Product Change Notification

PCN-ICC-6458-2021

Business Unit	Product Line Code	Type of Change	Action	Date of Issue
ICC - Industrial Cabinet	BE2	Product Change Notification	Notify Distributors and Field	1/19/2021

Description for Product Change Notification

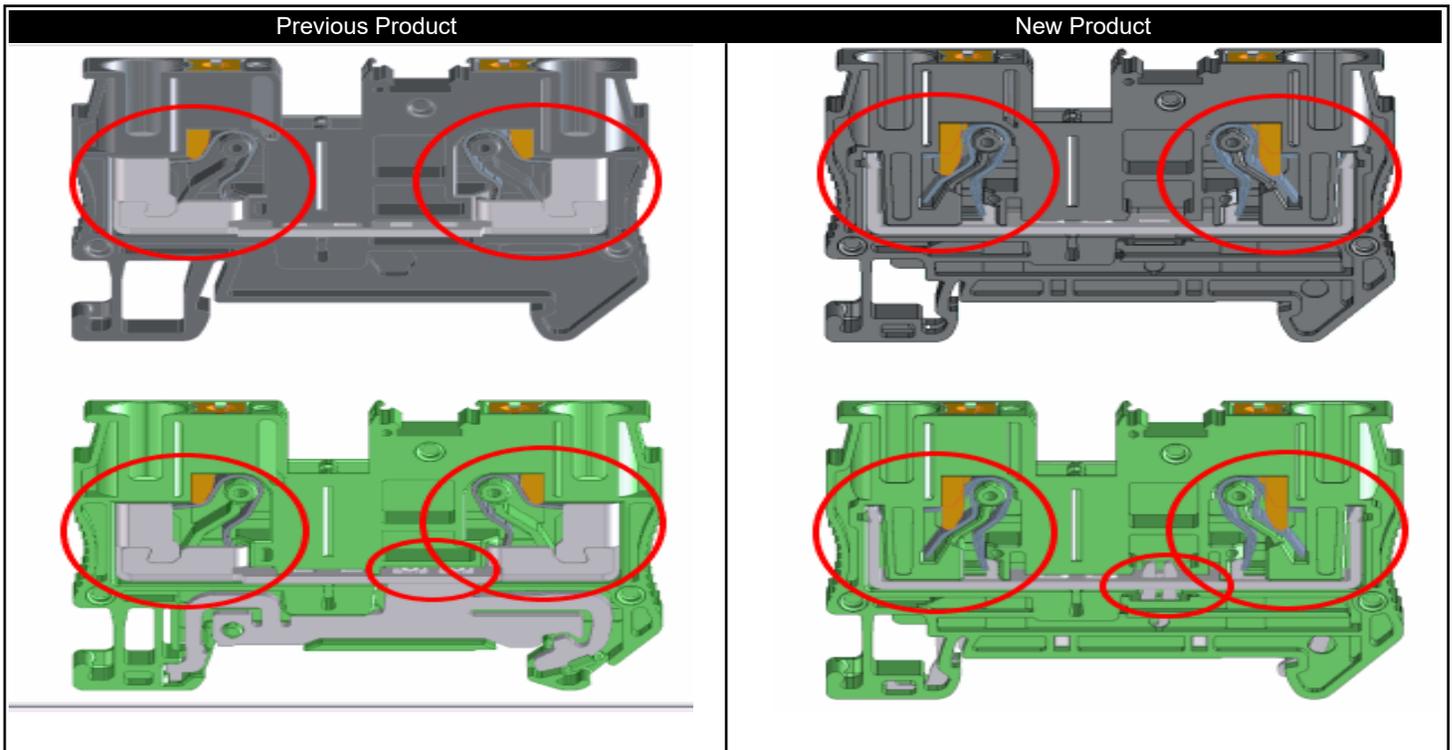
The Push-in conductor connection is being changed over to the familiar L-shaped current bar. Technical information such as current, voltage, approvals, accessories, etc. will not change. The old and new versions will be interchangeable. The -PE foot in the -PE versions will now be pressed into the current bar.
